SITE INSPECTION OF
ARMCO, INCORPORATED
KANSAS CITY, MISSOURI

GROUND WATER MONITORING COMPLIANCE INSPECTION REPORT

ARMCO, INC., KANSAS CITY, MISSOURI

MONITORING WELLS @ BAGHOUSE DUST PILE

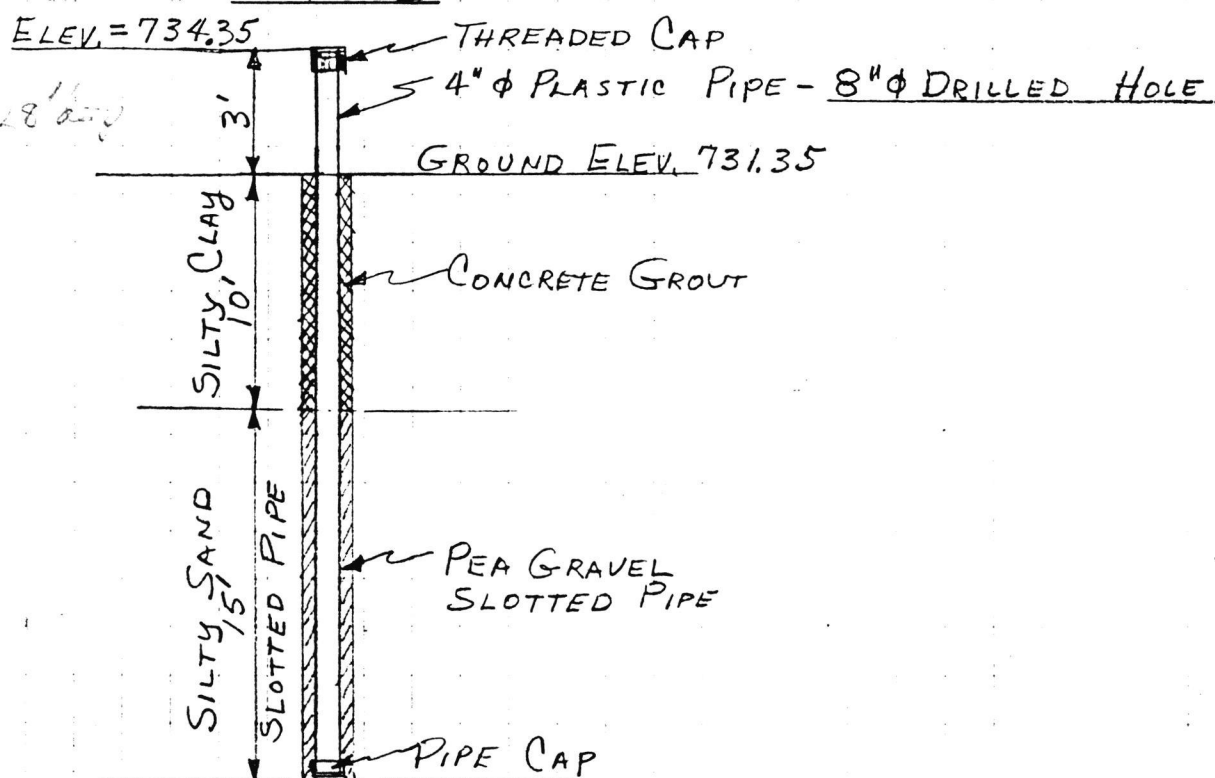
It also appears that the arrangement of the wells does not satisfy the requirement of one upgradient and three downgradient wells. The linear arrangement of the monitoring wells does not enable an accurate potentiometric (water table) contour map to be drawn. More site-specific hydrogeological information is needed to determine whether the upgradient/downgradient requirement is being met.

If yes, explain Discrepancies in all four wells
(compare well profiles with measured depths)

- ° Require Armco to adequately demonstrate that their present ground water monitoring system meets the requirements of §265.91(a) (1) and 265.91(a) (2). If it does not, require Armco to install additional monitoring wells in the vicinity of the waste pile to accurately define the direction of ground water flow.
